Summary	Replacement Relay Wiring				
Products Affected	Fast Fold Pneumatic, Relay Logic Controllers				
Key Word Tags					
Tools/Equipment (If Required)	Screwdriver				
Parts/Materials (If Required)	Relay R00112139 (120vac) Relay R00112140 (24v ac/dc) Relay Base R00112140				
Related Media					
Author	Sam Last	Issue Date	11/6/2020	Status

**TYPICAL RELAY WIRING: PNEUMATIC
FAST, AND OTHER RYTEC, RELAY
LOGIC DOOR CONTROLLERS**

11/6/20	WTS	RYTEC CORPORATION
P.O. BOX 400 JACONTA, WI 53027		
TYPICAL FLIP-FLOP RELAY CONNECTIONS		
ELECTRICAL CONNECTION DIAGRAM		
REV. #	00	00112142

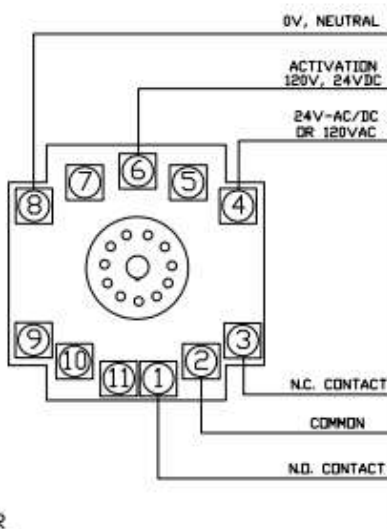
The original Relay used on the Fast Fold Pneumatic doors, and in Relay Logic Control Panels has been discontinued. Below you will find the wiring for the replacement Relay.

(PREVIOUSLY NOT REQUIRED)

THIS DRAWING
APPLIES TO
FOLLOWING DOOR
CONTROLLER DWGS
0499089 &
E4600
E4700
E4703
E4707
E4730
E4750
AND OTHERS
UTILIZING
DISCONTINUED PART
0011062

REPLACEMENT FLIP-FLOP RELAY CONNECTIONS

FOR USE WITH RELAY 00112139 (120VAC)
AND RELAY 00112141 (24V AC/DC)

BOTH RELAYS REQUIRE BASE (SHOWN)
00112140
